HOMES NSW

29 FLORIDA STREET  
SYLVANIA (SSD-83258708)

RESPONSE TO SUBMISSIONS

REVISION 04

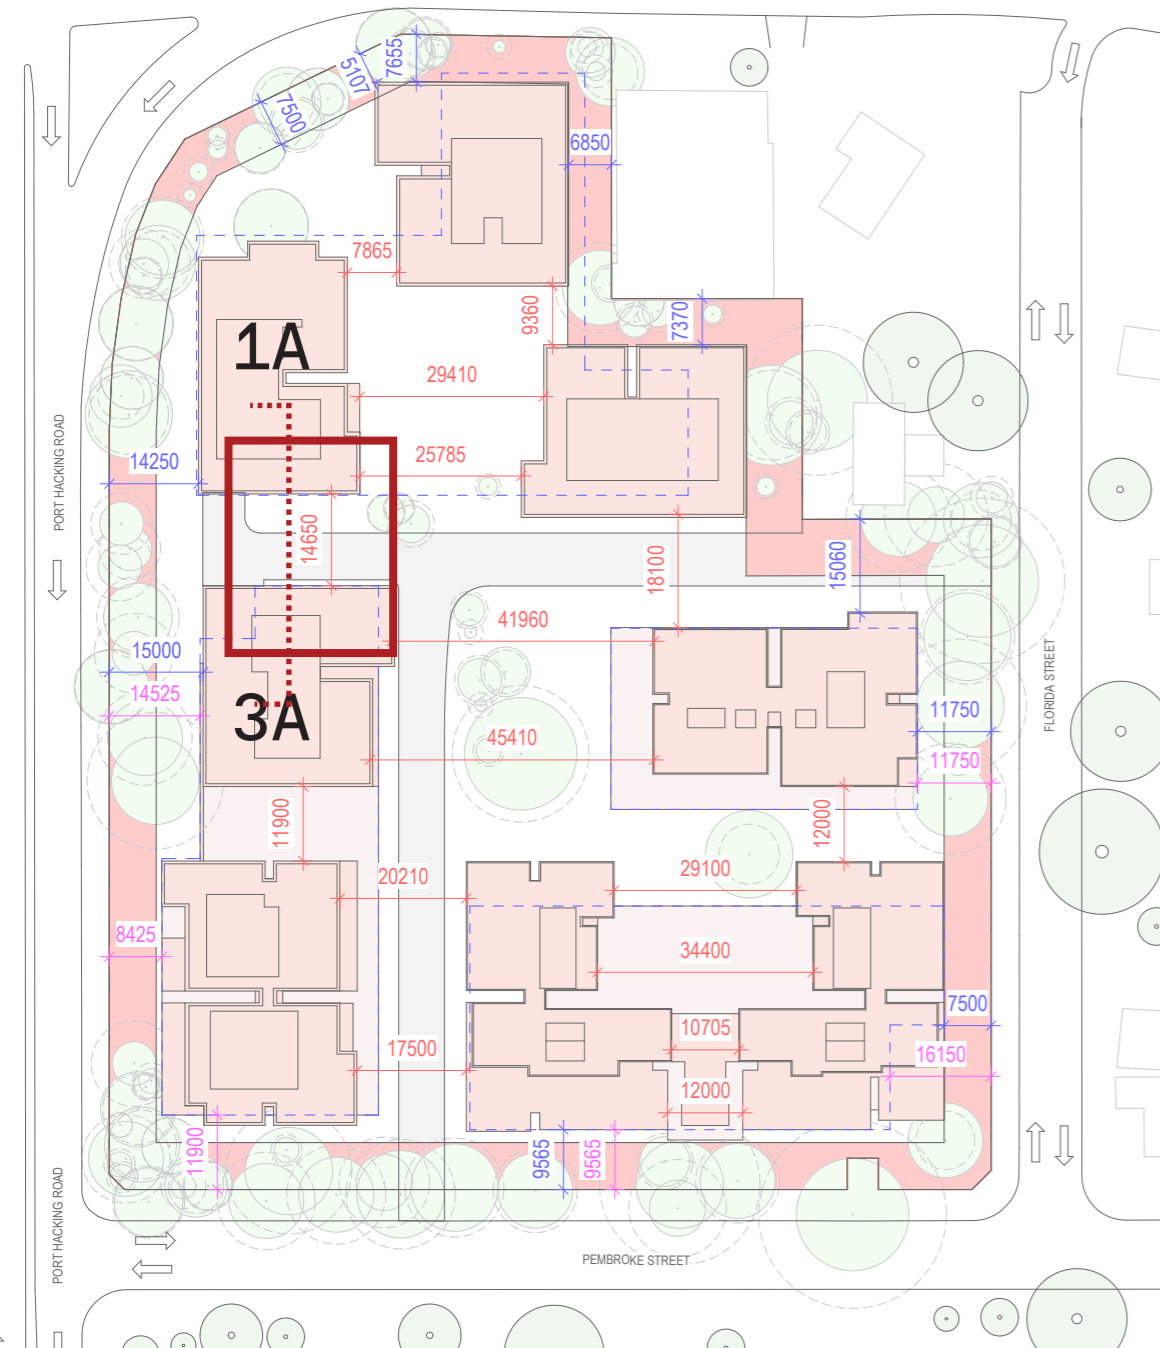
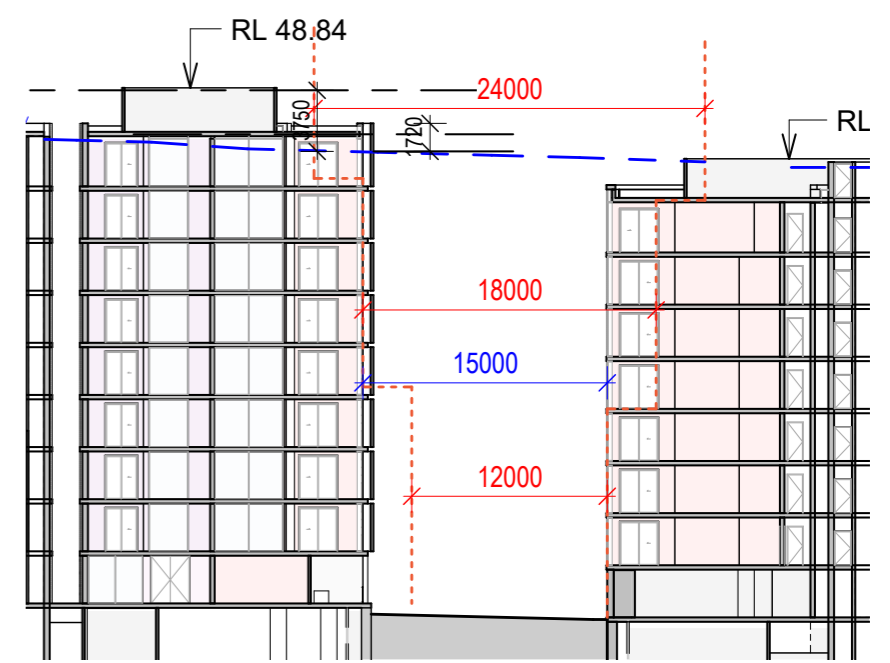
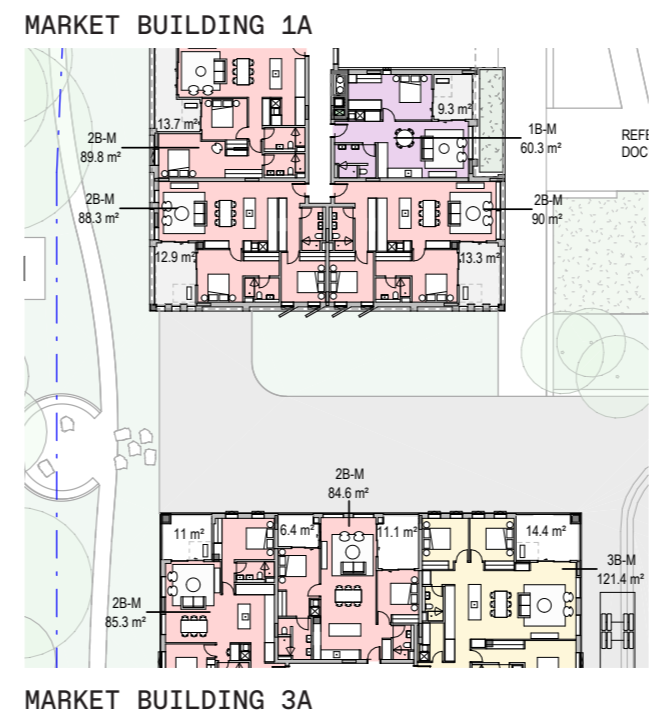
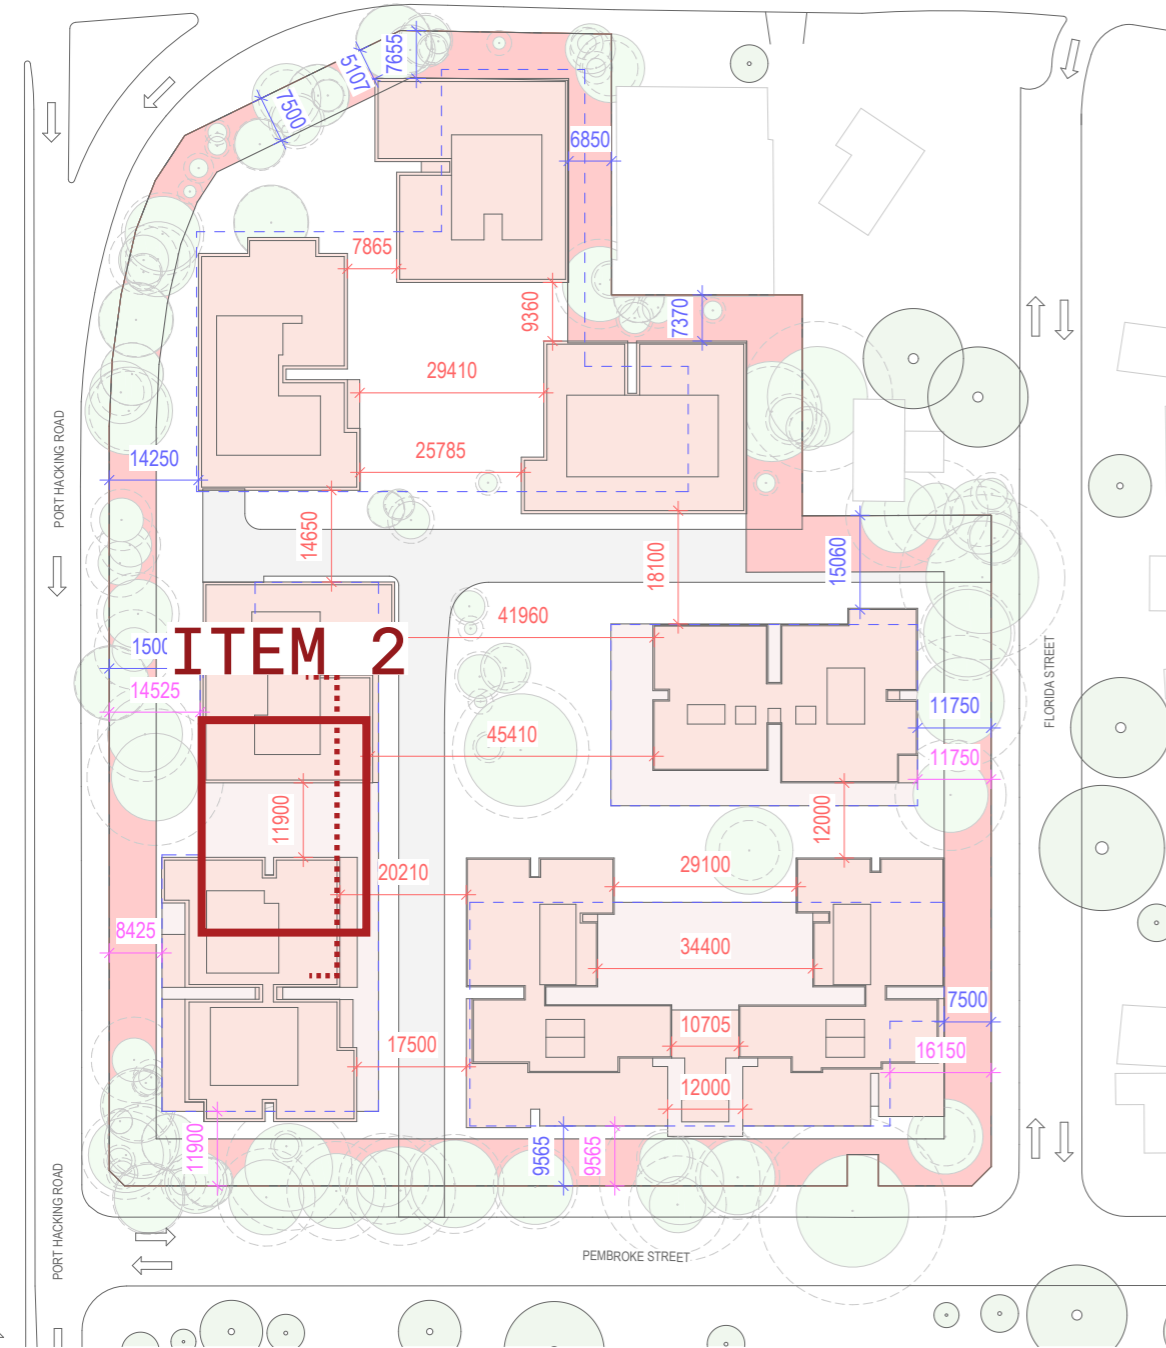
NO.	ISSUE RAISED	RESPONSE
<b>BUILT FORM &amp; URBAN DESIGN</b>		
4.1	Provide a schedule detailing where recommended Apartment Design Guide (ADG) building separation distances (i.e. Part 3F) are not achieved and the proposed mitigation measure (e.g., façade privacy screening as outlined in the Architectural Design Report) that are to be implemented to ensure satisfactory visual privacy is achieved.	A summary of non compliances with ADG building separations has been provided as part of the Archtiectural Design Report. Greater detail, locations and privacy amelioration techniques has been provided below.

LOCATION	DESCRIPTION	PRIVACY CONSIDERATION
1.0	Building separation between Market Building 1A and 3A along Port Hacking Road. Building separation between Levels 5 - Level 8 is 15m in lieu of 18m	Angled privacy screening to Market Building 1A applied to secondary bedrooms along the southern facade. Internal planning and arrangement of apartments orientates balconies and primary habitable spaces to the east and west. Balconies are screened with vertical pier elements

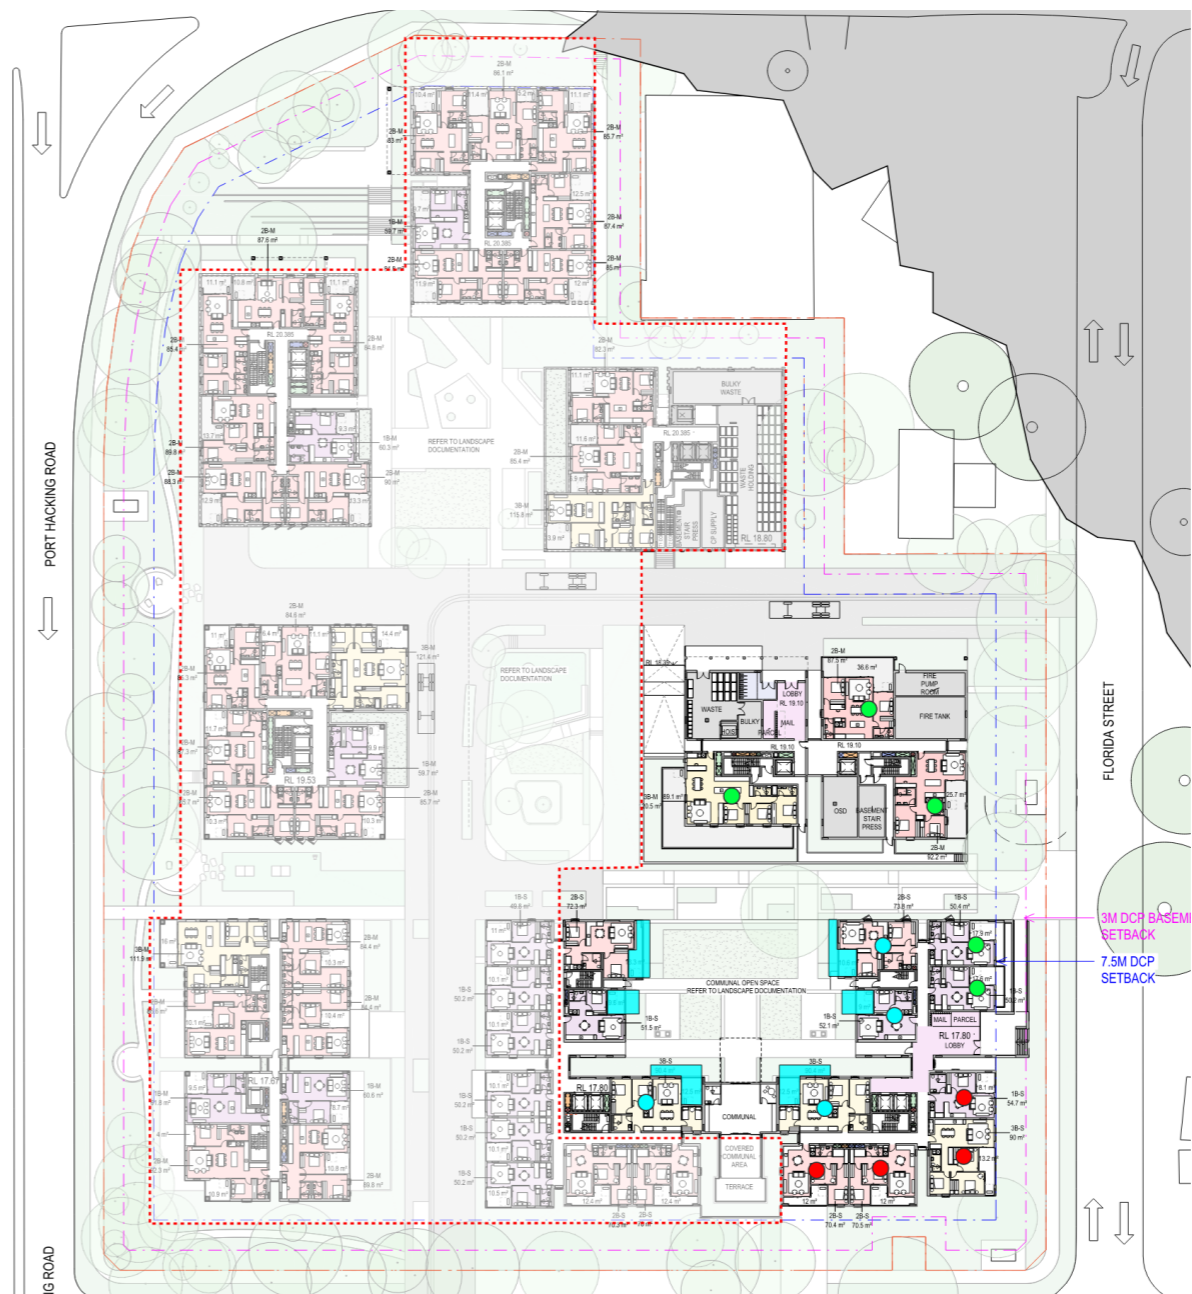
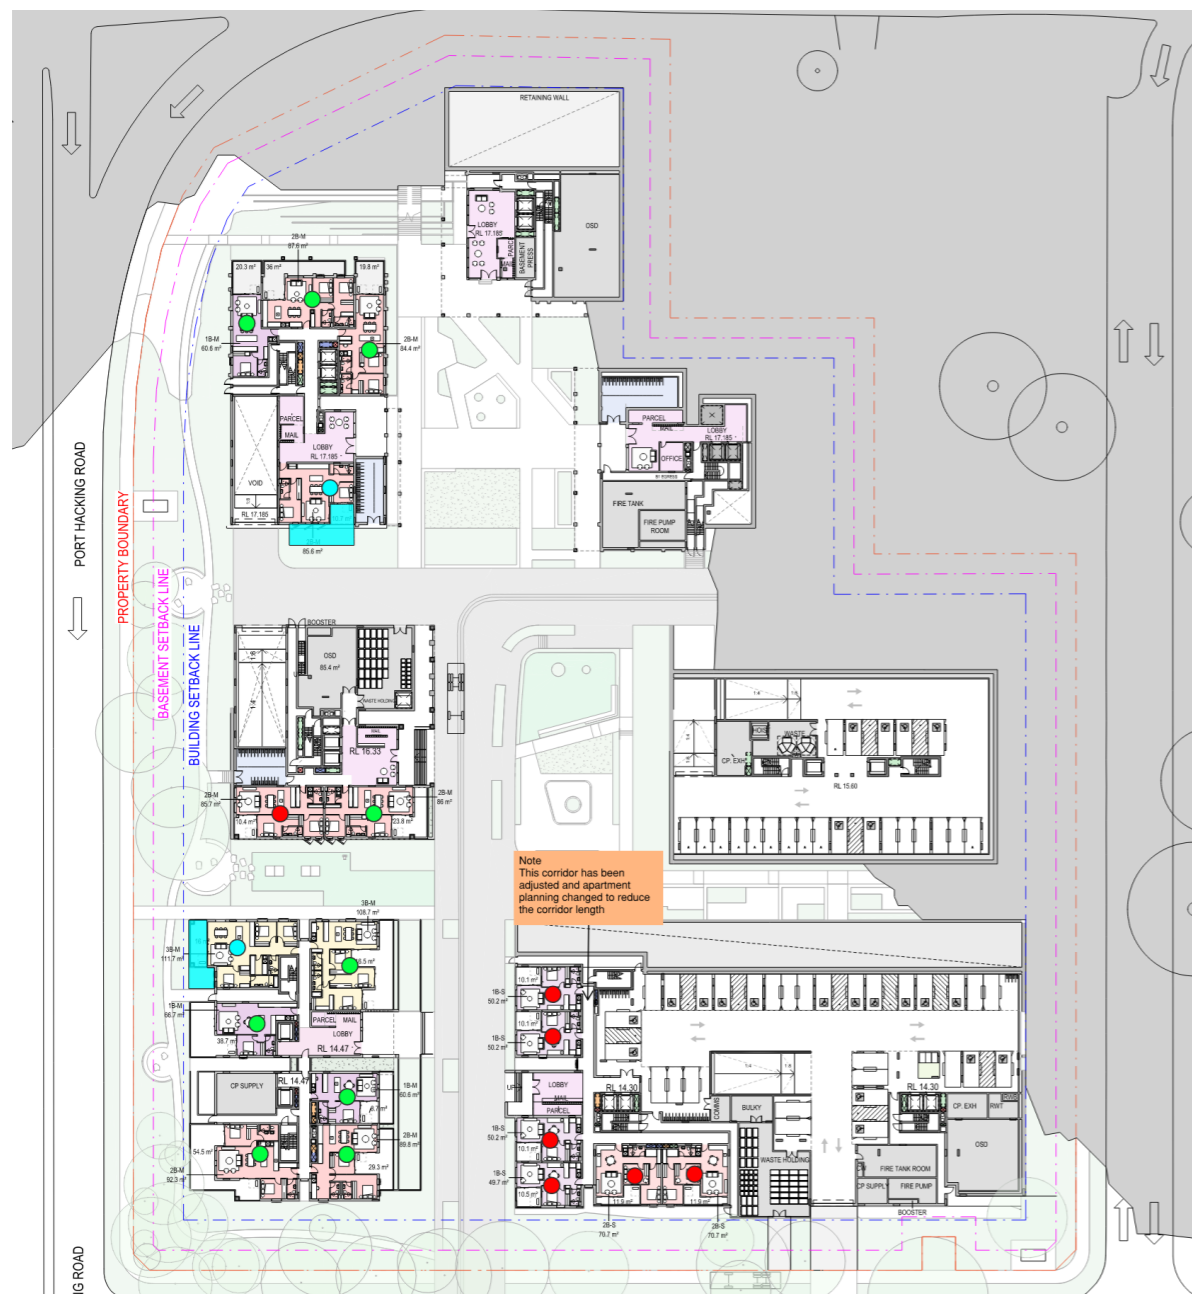
NO.	ISSUE RAISED	RESPONSE
<b>BUILT FORM &amp; URBAN DESIGN</b>		
5.2	Further detailed justification is to be provided (including design options) that supports the private open space for all ground floor units not achieving the dimensions recommended (area of 15 m <sup>2</sup> and depth of 3 m) in the ADG (4E Private Open Space and Balconies).	Ground floor terraces have been provided in all locations where achievable while navigating complex site conditions and topography. The diagrams below indicate where these have been provided, where minor adjustments have been made to the lodged documentation in order to achieve these requirements, and provide further explanation of areas this is not possible. These updates have been provided as part of the revised lodgement documents.

- MINIMUM DEPTH AND AREA ACHIEVED
- MINIMUM DEPTH AND AREA ACHIEVABLE WITH MINOR ADJUSTMENTS TO LANDSCAPE
- COMPLIANCE NOT ACHIEVED DUE TO LEVEL DIFFERENCES; THESE STILL ACHIEVE ADG MINIMUM BALCONY REQUIREMENTS

PROPOSED PLANNING AMENDMENT

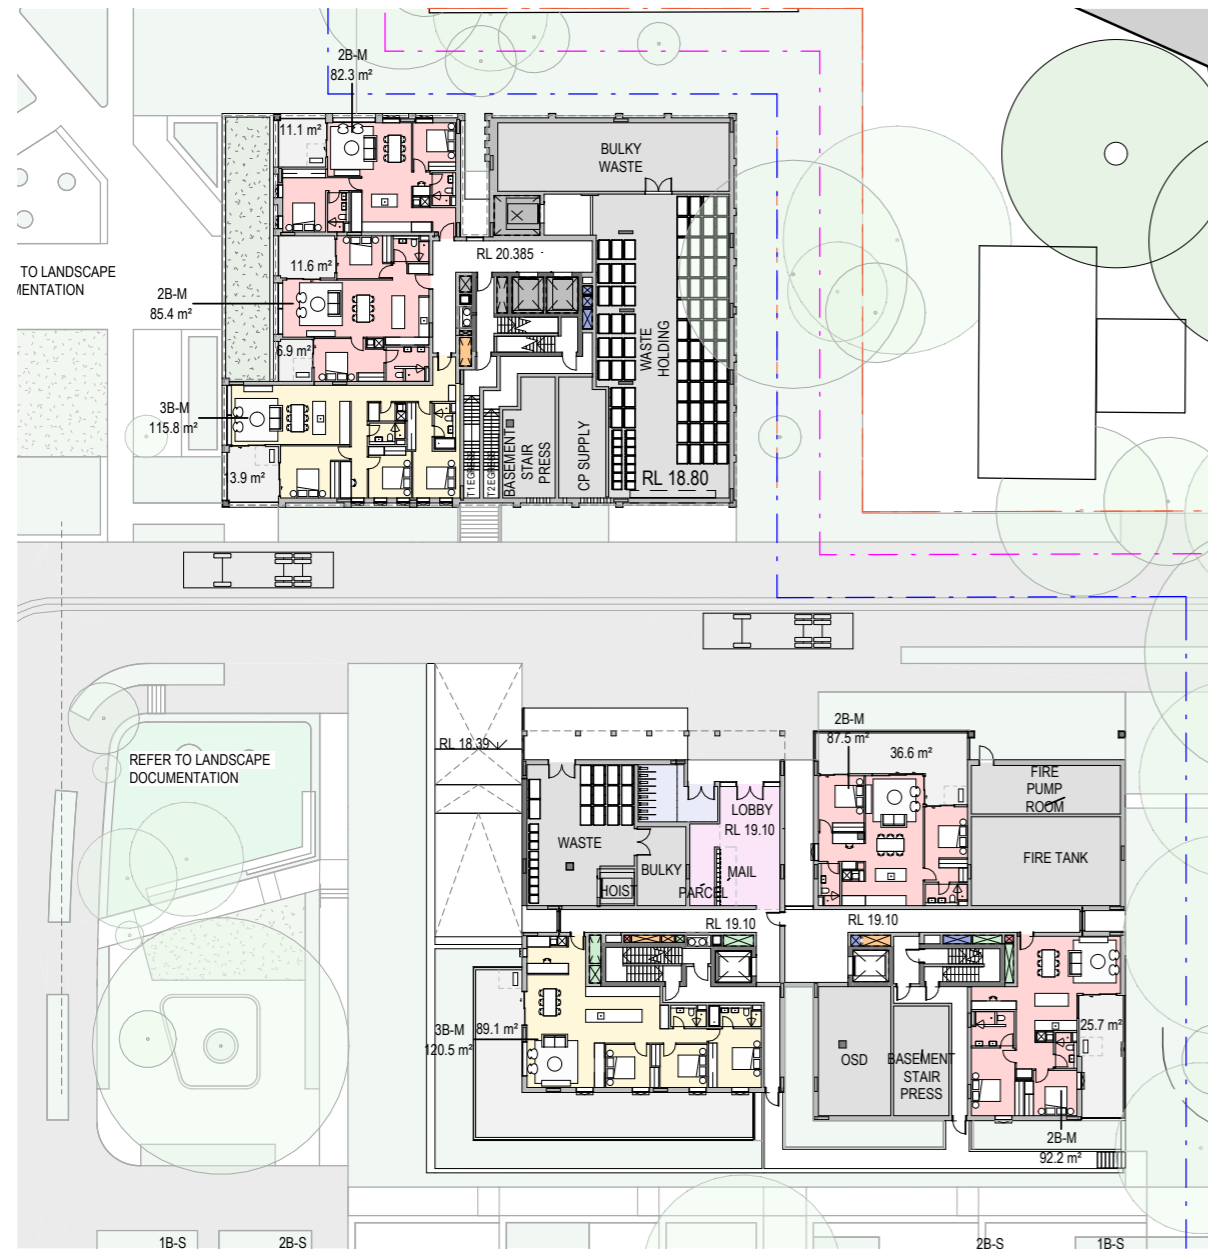
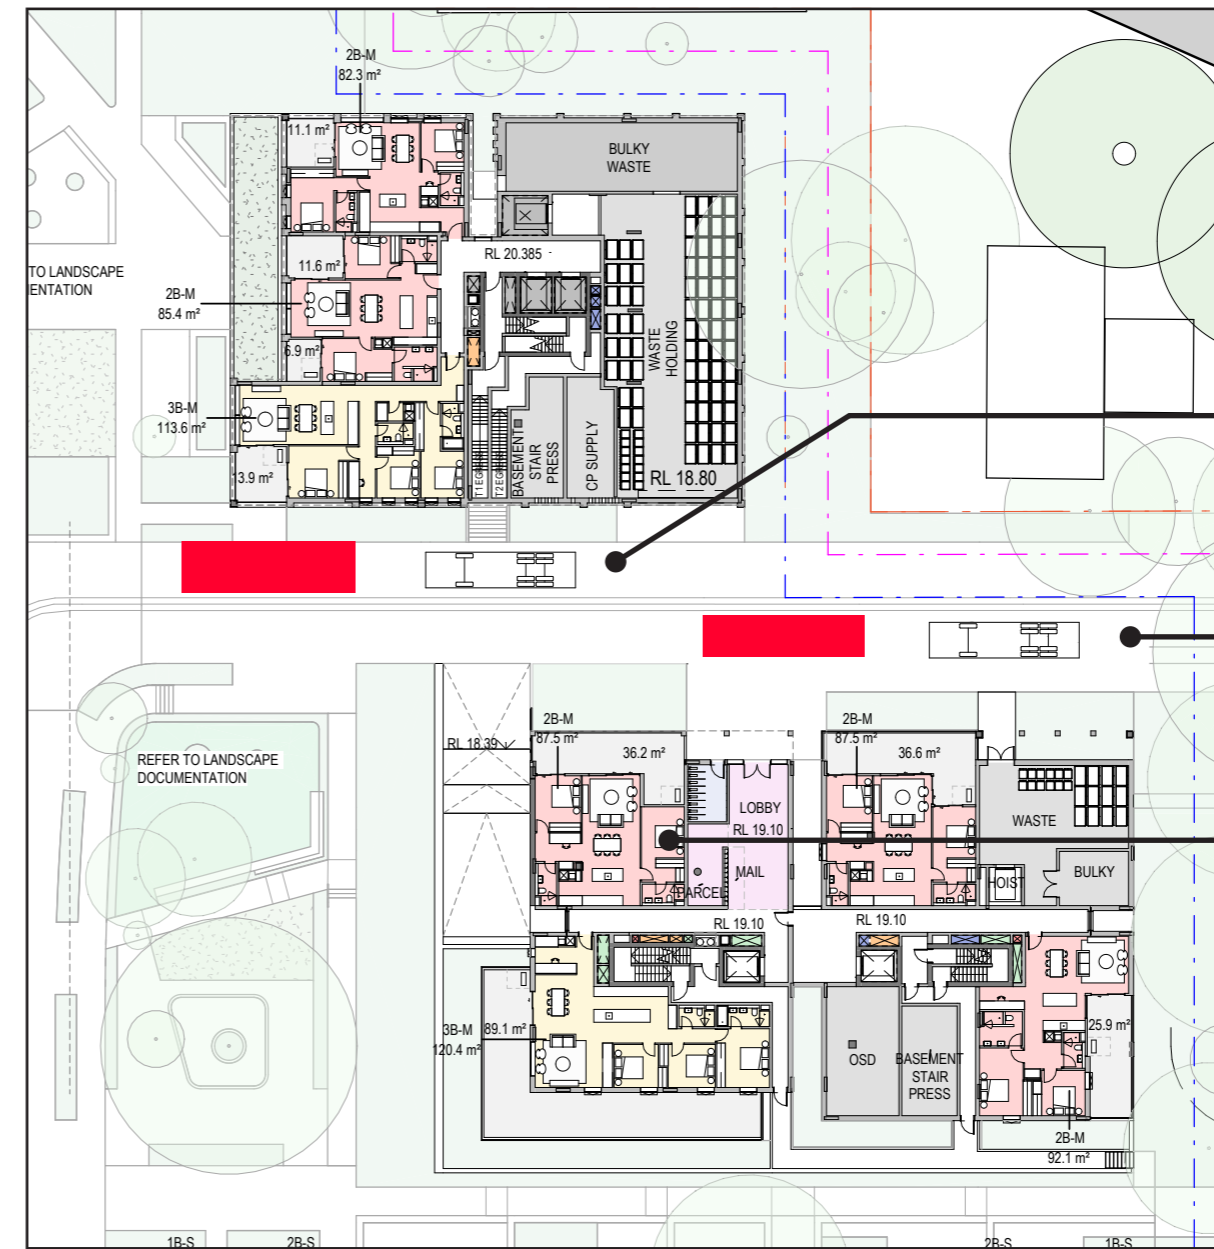
NO.	ISSUE RAISED	RESPONSE
<b>BUILT FORM &amp; URBAN DESIGN</b>		
7.1	As the proposal seeks to rely on Council's waste collection services, the waste servicing arrangements outlined in Council's submission dated 22 January 2026, along with Council's concerns with the design and function of the proposed internal road, must be addressed.	BVN have reviewed the proposed ground floor planning of Market Building 2 and coordinated with JMT Traffic and MRA Waste consultants to reduce the non compliant distances from waste room holding areas to waste vehicle parking on the internal road as reflected in the diagrams below. This will result in a minor re-plan of the lobby areas to the market building, and switching locations of the waste rooms with the 2bed on the other side of the lobby. As a result, waste vehicles servicing this building can park closer to Florida Street and, as indicated in the swept path, this will in turn shift the parking area for waste vehicles into Market building 3 closer to this waste holding area. Basement areas will also need a minor re-plan to coordinate hoist locations bringing waste bins up from the basement. Further clarification and detail has been provided as part of responses to submissions from waste and traffic consultants.

- WASTE VEHICLE SWEEP PATH FROM MARKET BUILDING 2 ALLOWS THIS PARKING AREA TO MOVE CLOSER TO THE WASTE HOLDING AREA AND REDUCE THE DISTANCE TO BELOW 10M
- WASTE VEHICLE PARKING TO SERVE MARKET BUILDING 2 IS WITHIN 10M OF WASTE HOLDING AREAS AND IS AT GRADE
- 2BED LOCATION SWITCHED TO OTHER SIDE OF LOBBY TO LOCATE WASTE FACILITIES CLOSER TO FLORIDA STREET FOR MARKET BUILDING 2
- ADDITIONAL CHANGES TO GROUND FLOOR FIRE PUMP ROOM AND TANK AREAS HAVE BEEN INCLUDED AS PART OF RESPONSES TO OTHER ITEMS
